Oklahoma Uniform Building Code Commission

PUBLIC COMMENT FORM FOR THE ADOPTION OF BUILDING/CONSTRUCTION CODES PROPOSED CHANGE TO THE INTERNATIONAL RESIDENTIAL CODE®

Section: 403.1.9.1 Table: _____ Figure: _____ Page No: _____

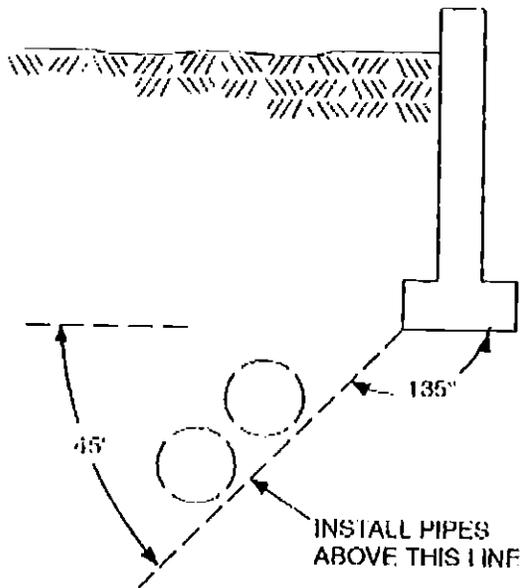
Add section P2604.4 to Chapter 4 create new section R403.1.9.1

R403.1.9.1 Protection of Footings. Trenching for work including but not limited to plumbing, electrical, storm shelters, and pools shall comply with this section. Trenching installed parallel to footings and walls shall not extend into the bearing plane of a footing or wall. The upper boundary of the bearing plane is a line that extends downward, at an angle of 45 degrees from horizontal, from the outside bottom edge of the footing or wall.
